SPECIAL TOWNSHIP BOARD MEETING
LOCATION: 7527 HIGHLAND ROAD, WHITE LAKE - ANNEX BOARD ROOM
TUESDAY, JANUARY 25, 2022 – 6:00 PM

**SUBJECT: 4 Corners Square Retail Outlot
Preliminary and Final Site Plan Approval**
Property described under parcel number 12-36-476-032 (1449 Union Lake Road) located on the east side of Union Lake Road north of Cooley Lake Road, consisting of approximately 0.71 acres, and is currently zoned Neighborhood Mixed Use (NMU).

RE: Four Corners Outlot- Preliminary Site Plan, Final Site Plan/Final Engineering Plan Review – 2nd Review

RE: Four Corners Square – Retail Center #2
Preliminary and Final Site Plan – Review #2

B WEST BUILDING ELEVATION
 SCALE: 3/16" = 1'-0"

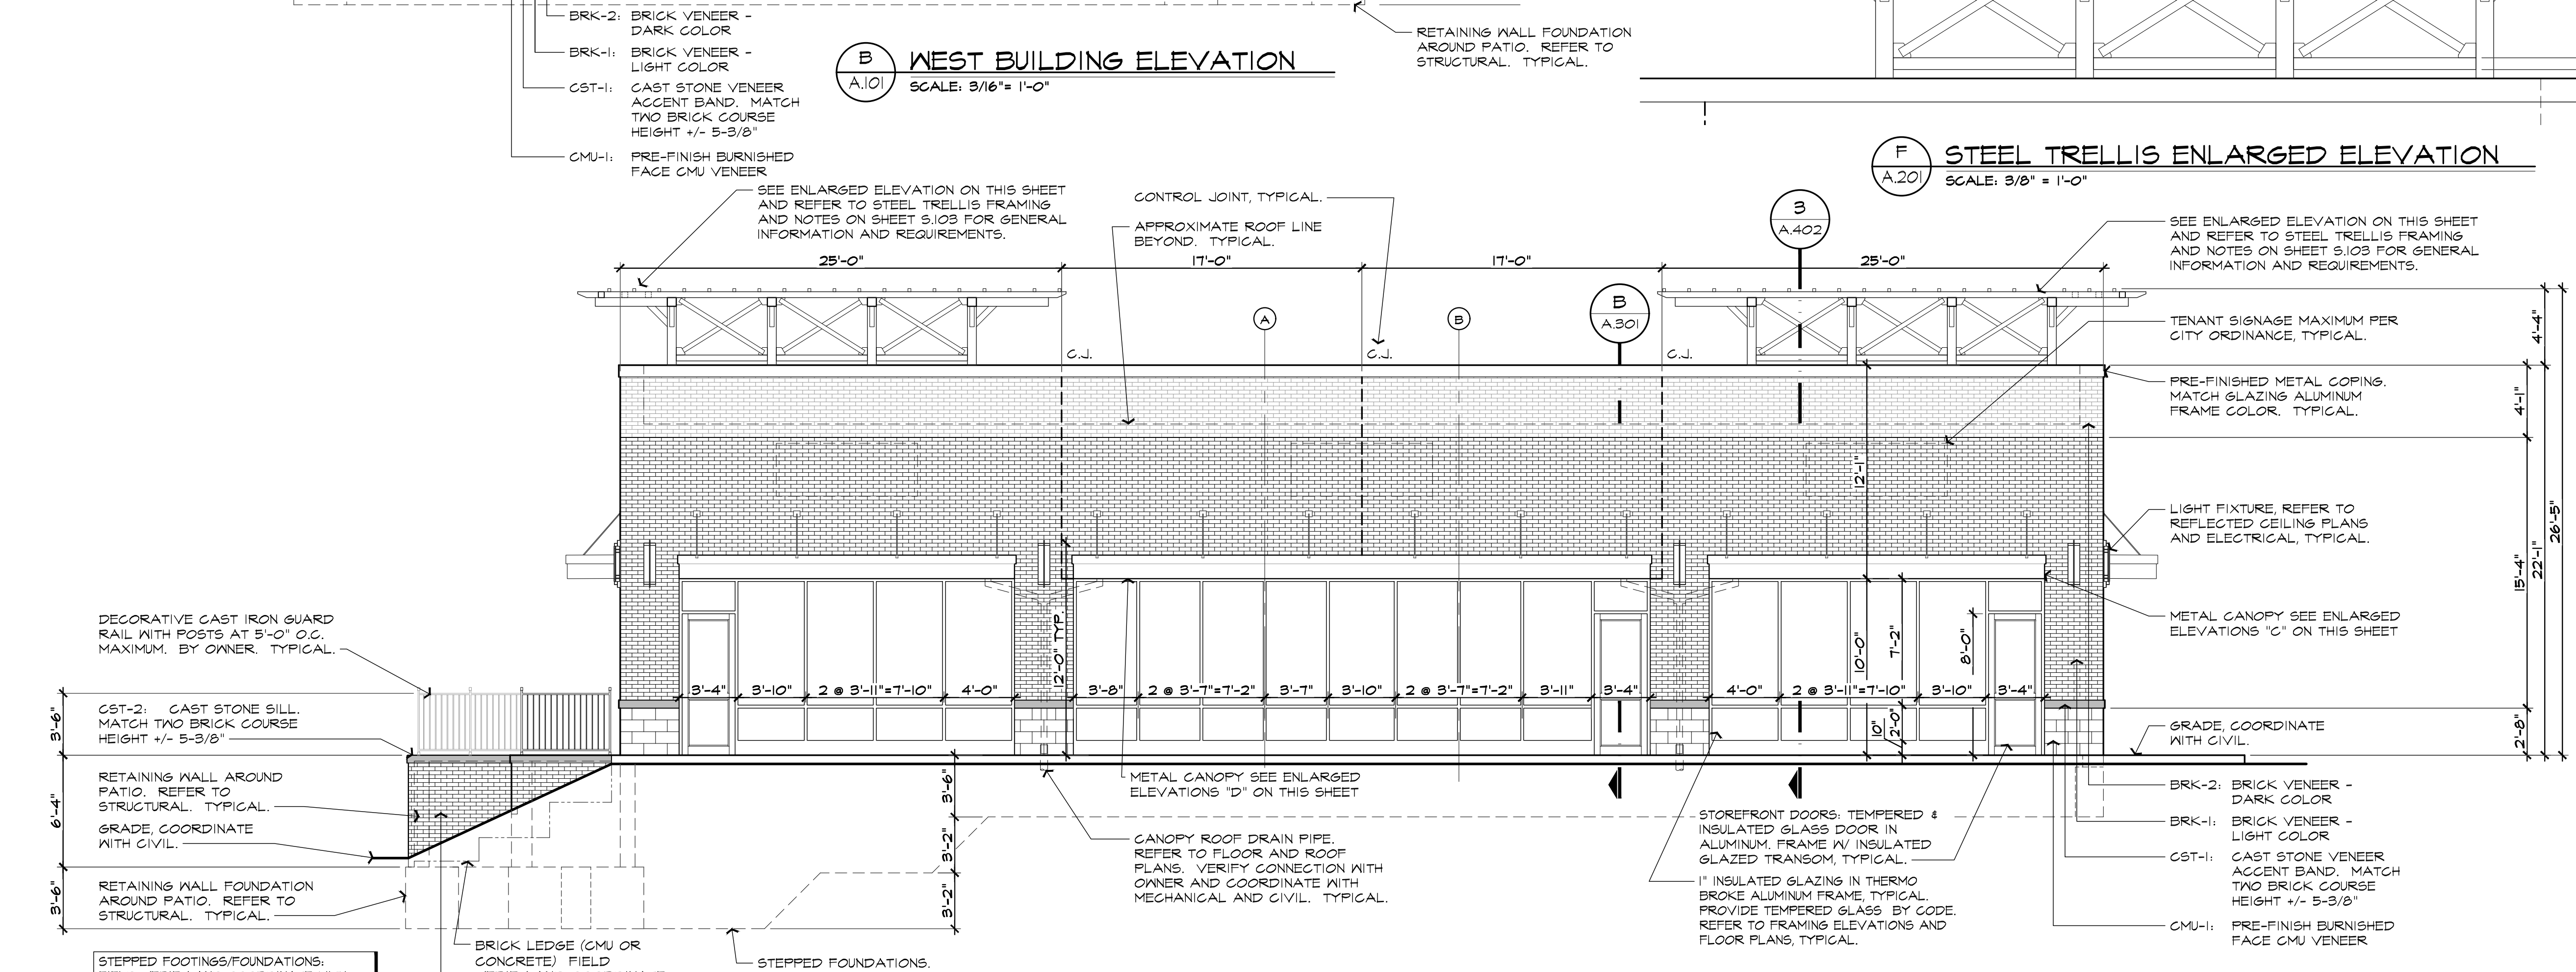
Member Seiber said the tenants in the adjacent shopping center did not have corner signs, and because of the way the building was situated, the east side sign would not be visible from travelers on the road. He added the floor plan was inconsistent with the elevation as there was a door shown on the east side elevation, but not on the floor plan. Mr. AlKhafaji said a door was not proposed on the east side of the building and the elevation was incorrect.

- **The exterior elevations be revised to remove the east side door.**
- **The Applicant shall obtain all necessary permits from the White Lake Township Building Department.**
- **The Applicant shall receive preliminary site plan approval from the Township Board.**
- **For the purpose of administrating the sign ordinance, signs on the subject property shall be treated as those in the RB (Restricted Business) zoning district and meet the requirements of Article 5, Section 9.J of the zoning ordinance.**
- **No additional signage shall be permitted on the building or site, except for the Township's "Welcome to White Lake" sign. The "Welcome to White Lake" sign is to be designed to meet the requirements of the ClearZoning Ordinance.**
- **Any future modification to signage on the building or site, except for eliminating signage, shall require approval of the Zoning Board of Appeals.**

D EAST BUILDING ELEVATION
SCALE: 3/16" = 1'-0"

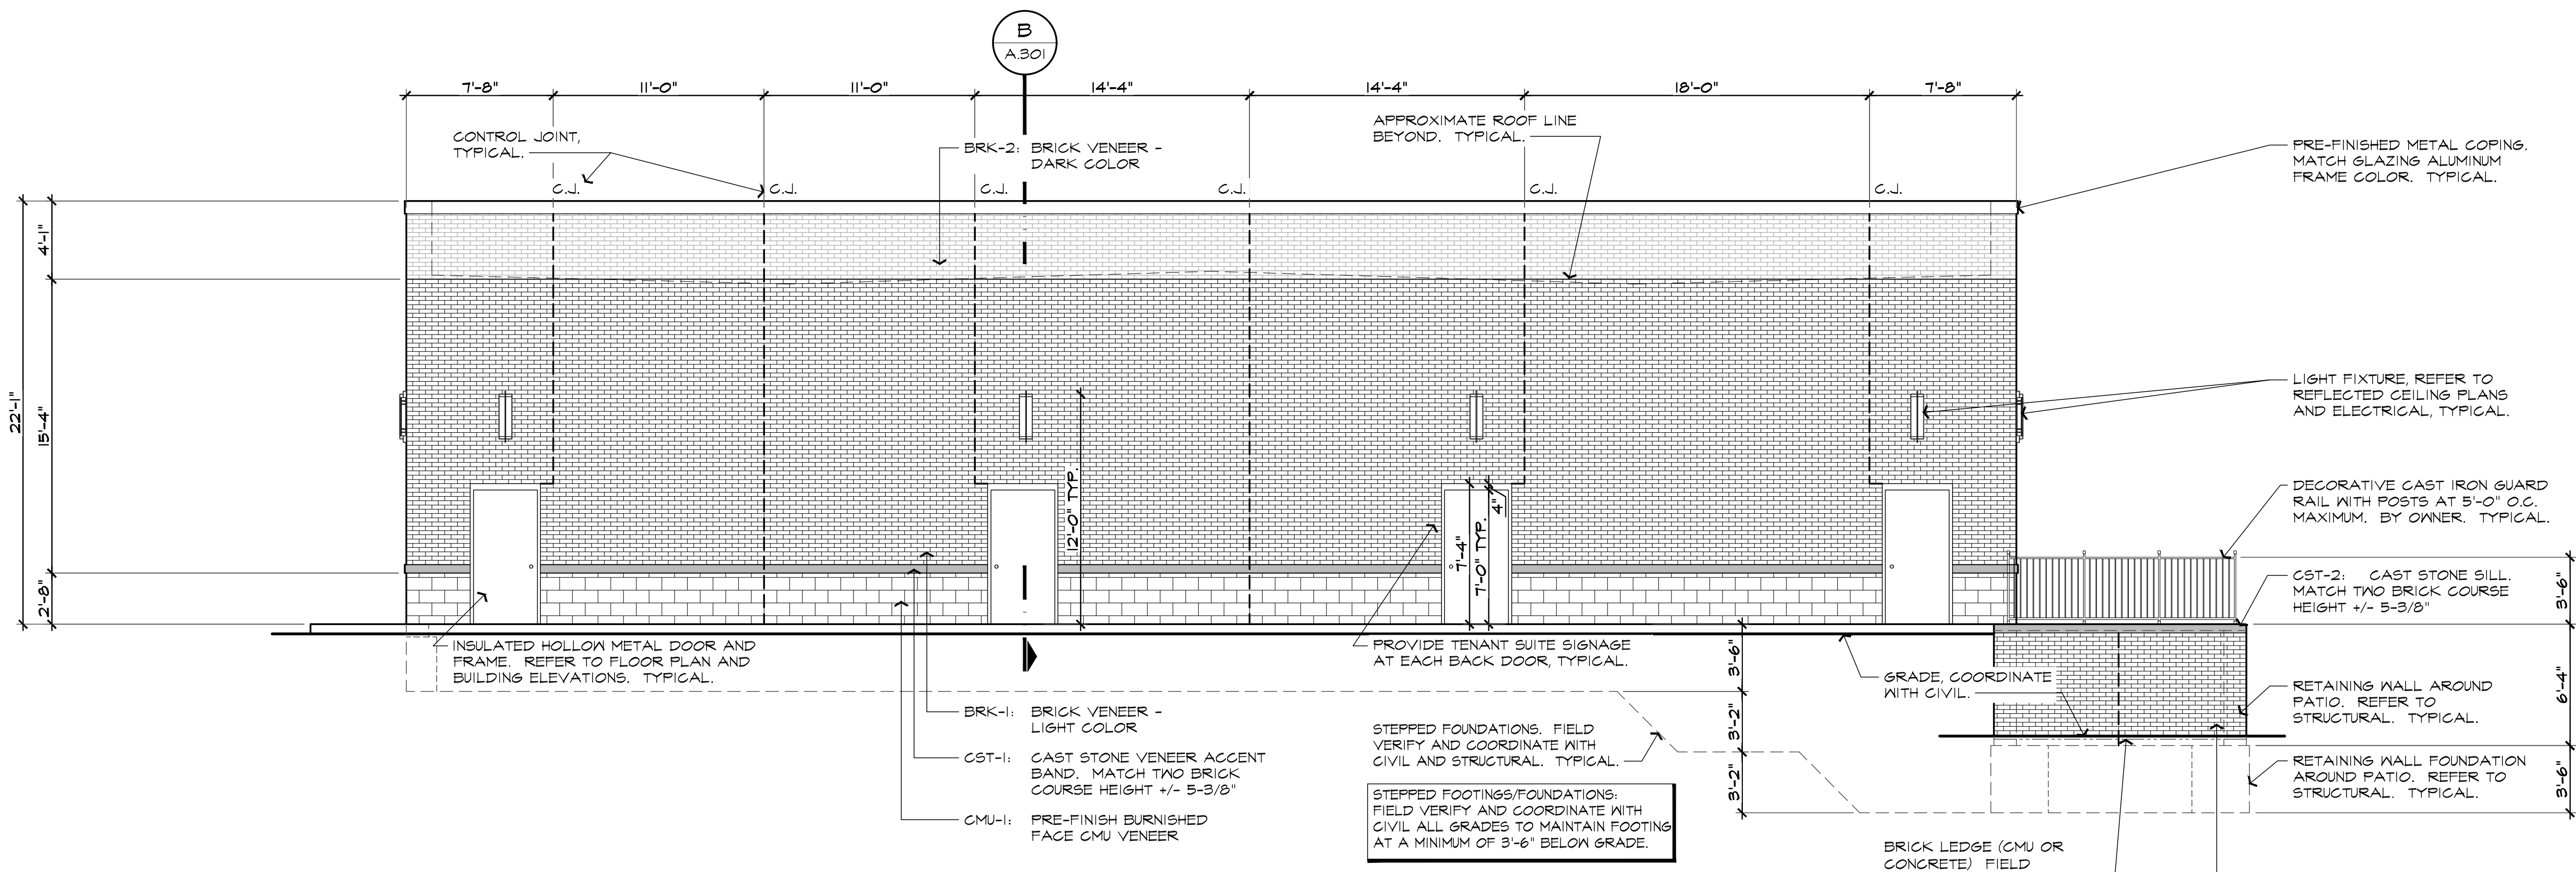
- A. Practical Difficulty
 - Chairperson Spencer did not see a practical difficulty.
- B. Unique Situation
 - Member Powell said it was a corner lot, so a sign on the west facade was permitted. He added a sign on the east elevation was not needed.
- C. Not Self-Created
 - Chairperson Spencer said this problem was self-created by the applicant.
- D. Substantial Justice
- E. Minimum Variance Necessary
 - Chairperson Spencer said by eliminating the wall sign on the east elevation, the minimum variances necessary would be granted.

3 TYPICAL BOLLARD DETAIL
 A.501 NOT TO SCALE

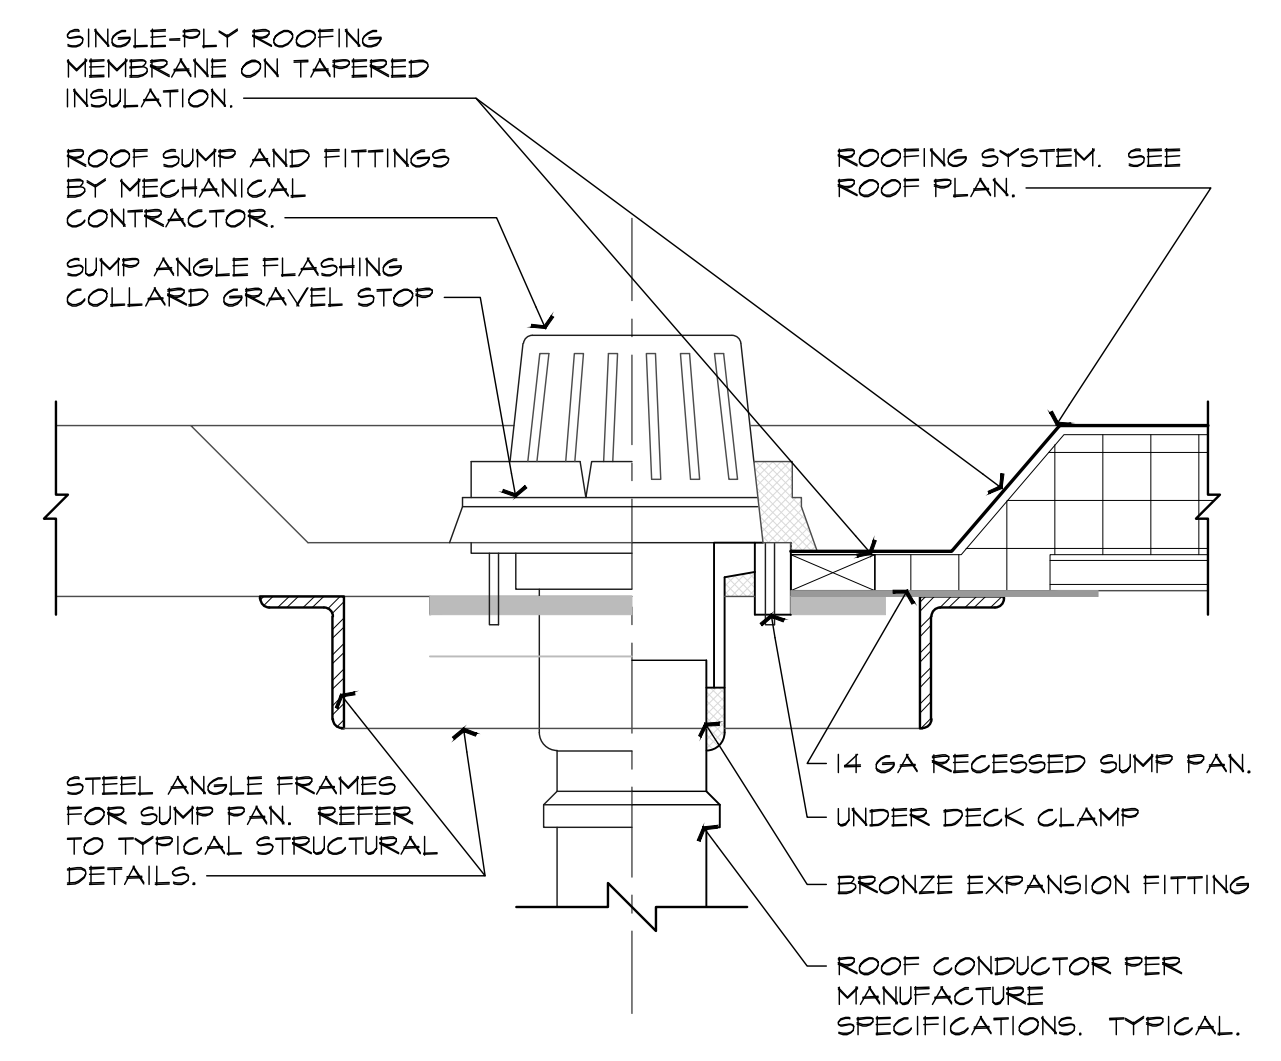
5. *The bollards for the dumpster enclosure shown on Sheet C7 will need to be 6" diameter instead of 4" diameter and also on Sheet A.502 where 5" diameter bollards are proposed. **Comment partially addressed. The bollard diameter is now correct (6") on Sheet C8; note that we did not receive Sheet A.502 as part of this submittal. The diameter of the bollard shall be revised on Sheet A.502 as well.***
